COMMITTEE: Planning Committee
MEETING DATE: 19 August 2025
BY: Executive Director for Place
REPORT TITLE: Energy Consents Unit Consultation for Consideration

Application No. 25/00001/SGC

Proposal Section 36: The development of a Battery Energy Storage System (BESS) and associated infrastructure, including connecting underground cabling to the existing substation, on approximately 1.4 hectares of land north of Pitcox, East Lothian, EH42 1RG (ECU00004992)

ENERGY CONSENTS UNIT (“ECU”) CONSULTATION: PROPOSED BATTERY ENERGY STORAGE SYSTEM ON LAND NORTH OF PITCOX NEAR DUNBAR, EAST LTOHIAN (REFERRED THROUGHOUT THIS REPORT AS “PITCOX BESS”), EAST LOTHIAN COUNCIL’S RESPONSE

Figure 1 – Indicative lines for sections required

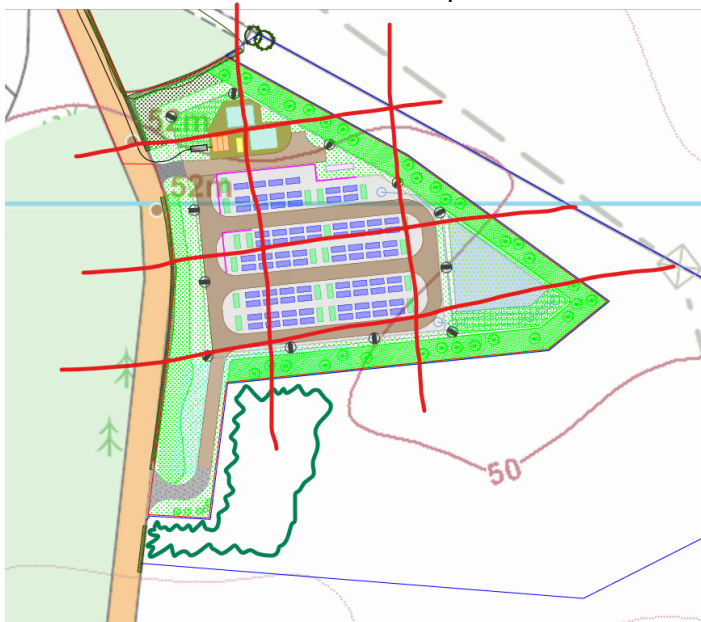
Given the local undulations on the site we have concern that this may require platforming of sections of the site to provide level access and construction platform. No drawing showing existing and proposed levels appears to have been submitted. In addition no sectional drawings across the site appear to have been submitted. Changing the levels within the site could increase the landscape impact of the proposals. We require this information to enable a full understanding of the impact of the proposals on the landscape to be made. I have shown indicative lines for the sections required on the sketch below.
